Providence Bicycle and Pedestrian Advisory Commission

Staff Report: Potential improvements to Tobey, Ridge, Swiss, and Knight streets north of

Broadway – Federal Hill – Ward 13 (For Action) Presented at October 16, 2016 BPAC meeting

Project Map

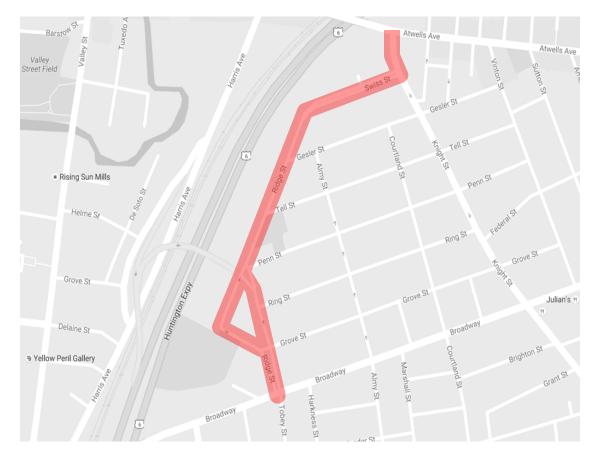
- The curb radius of the northeast corner of Tobey Street and Broadway should be reduced to decrease vehicular speeds and improve pedestrian safety.
- Tobey Street, between Broadway and Penn should be made two way and the portion of Ridge Street between Broadway and Grove Street should be abandoned and turned into a green space and bicycle/pedestrian connection to Bell Street Park. This would improve pedestrian safety in this area by reducing the length of the pedestrian crossing, create a welcoming entrance to the park, and reduce the amount of impervious pavement in the city.
- The Tobey/Ridge/Penn

intersection should be reconfigured to reduce vehicular speeds and improve pedestrian safety as part of RIDOT's work to redesign and reconstruct the Tobey Street bridge over the 6-10 Connector.

- Swiss Street should be redesigned to reduce the curb to curb width, reduce vehicular speeds, eliminate the median, and create safer accessible pedestrian crossings.
- Knight Street between Atwells Avenue and Swiss Street should be redesigned to reduce the curb to curb width, reduce vehicular speeds, eliminate the median, and create safer accessible pedestrian crossings.
